Cordillera Valley Club

Design Review Board

Meeting Agenda

Cordillera Valley Club Design Review Board *Staff Memorandum*

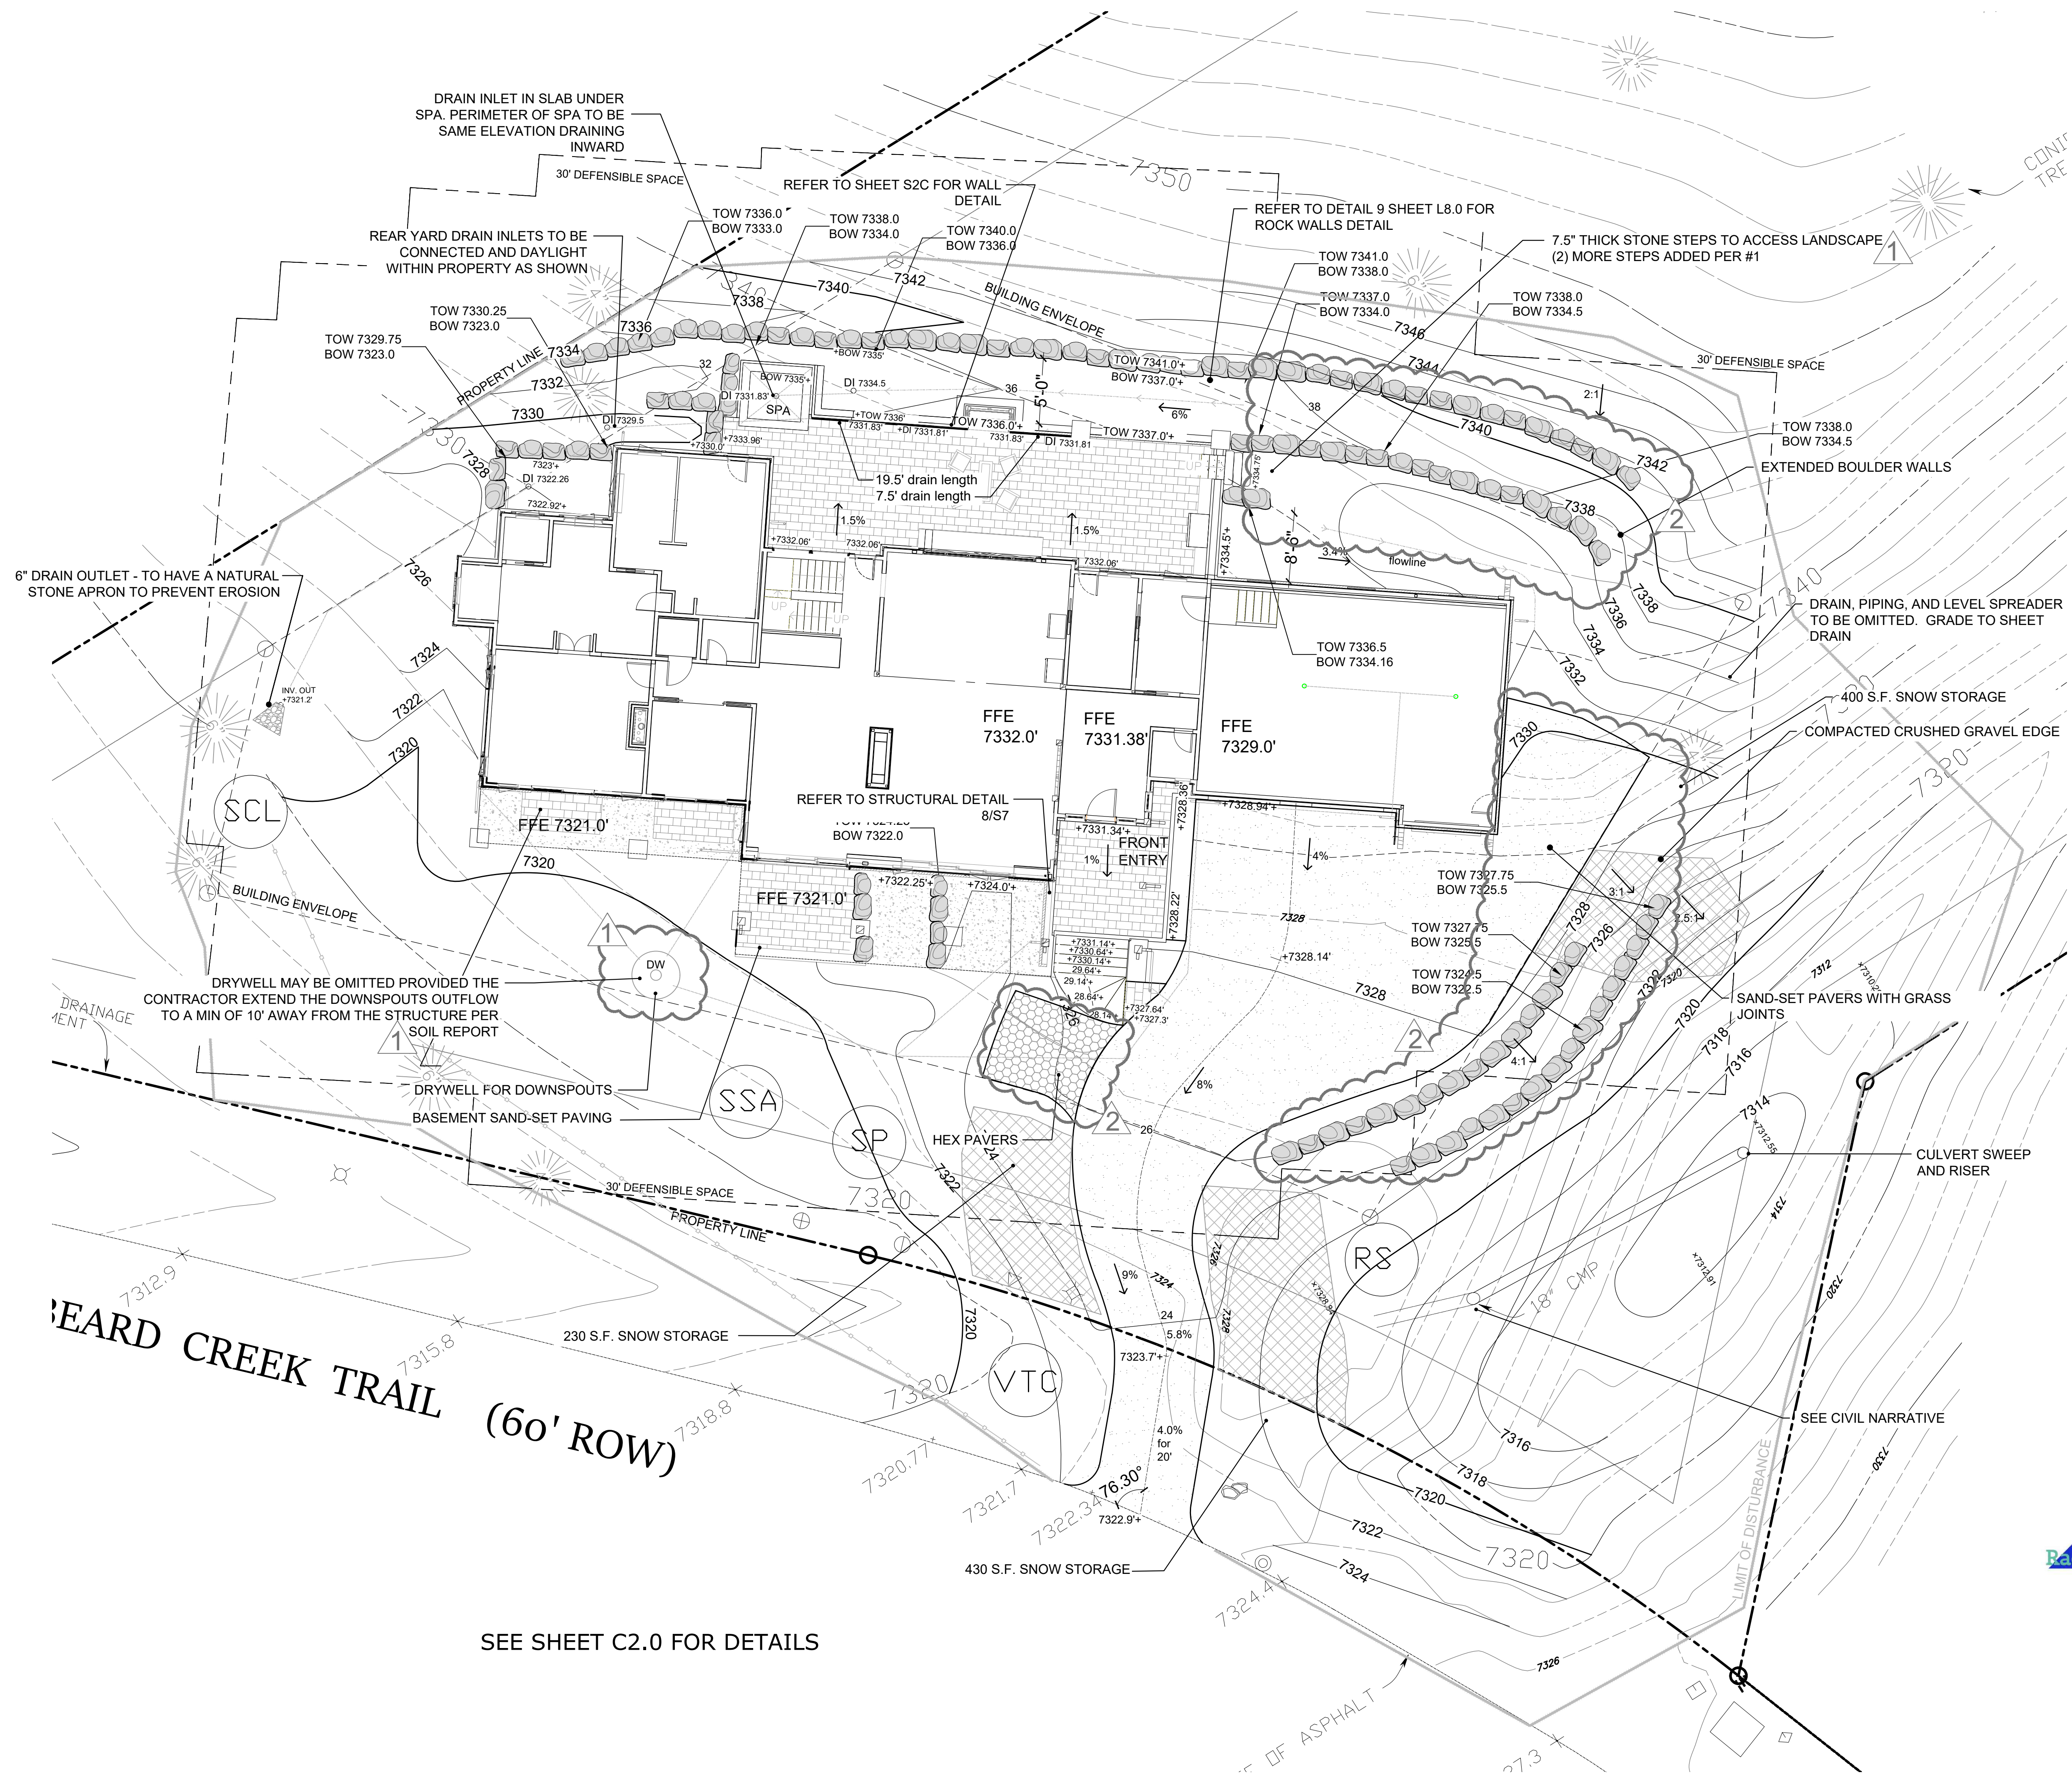
- Clouded revisions on sheet C1.0 & L3.0 submitted for DRC record.
SRI & Pinon Sage have further reviewed the driveway area required for safe and effective vehicle access in and out of the garages. The modified boulder walls with eased radius to better relate with existing site conditions, driveway slope and adjusted to better follow the building envelop east/southeast edge of driveway. The modification reduces the elements previously extending into steeper existing slopes that required more excess fill which is not desired. We feel these modifications will allow owners to safely navigate the driveway.

C1.0

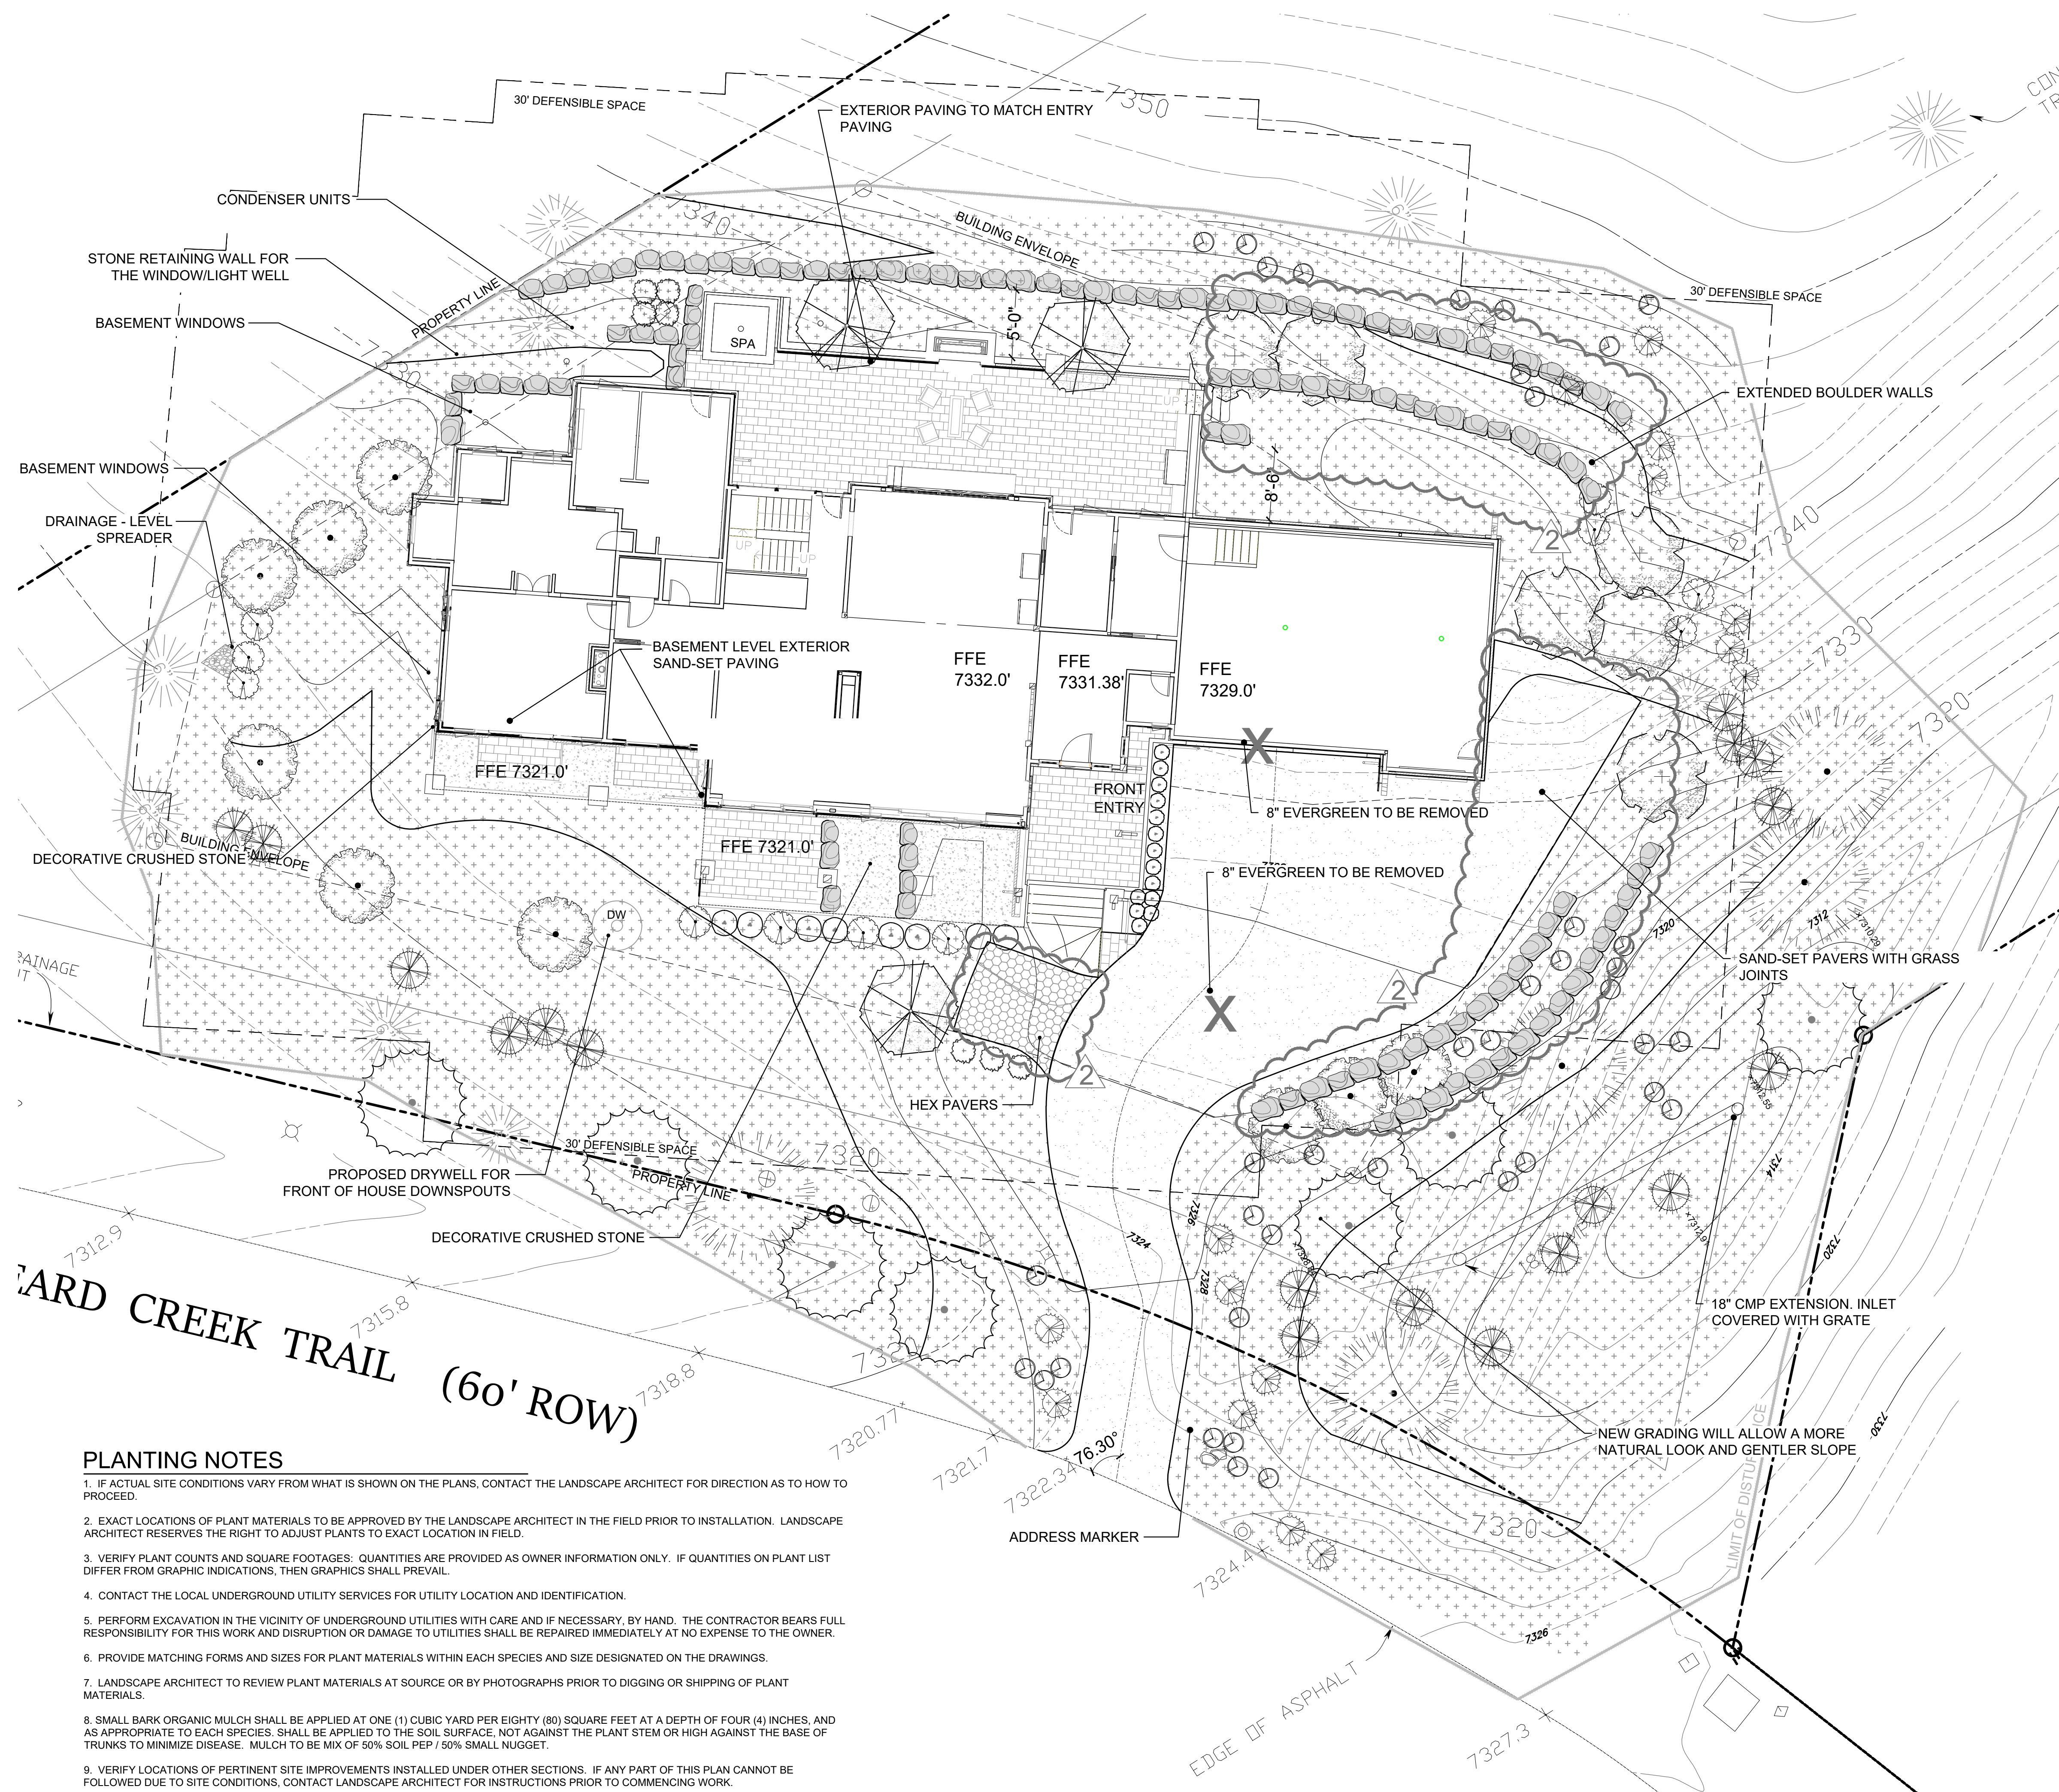
1. At each level of review, the driveway area, retaining walls, and the extent of disturbance that resulted within the existing drainage feature was a critical area of discussion with the DRB. The DRB continually required that the driveway area be minimized and that the retaining walls be within the building envelope to the extent possible. Staff is concerned that the proposed site plan changes are contrary to the direction given by the DRB and simply another attempt to go back to a design that was previously rejected by the DRB. Staff recommends the DRB provide input on the proposed changes.

2. In addition to the retaining walls at the driveway which are outside the building envelope, additional retaining walls have been constructed at the rear of the home that were not approved by the DRB. These retaining walls are outside the building envelope to a much greater extent than the approved plans allowed for. This necessitated the need for the DRB to review this as a Deviation from the Design Guidelines. Staff recommends the DRB provide input on the proposed deviations. The DRB must make the following findings to approve a deviation:
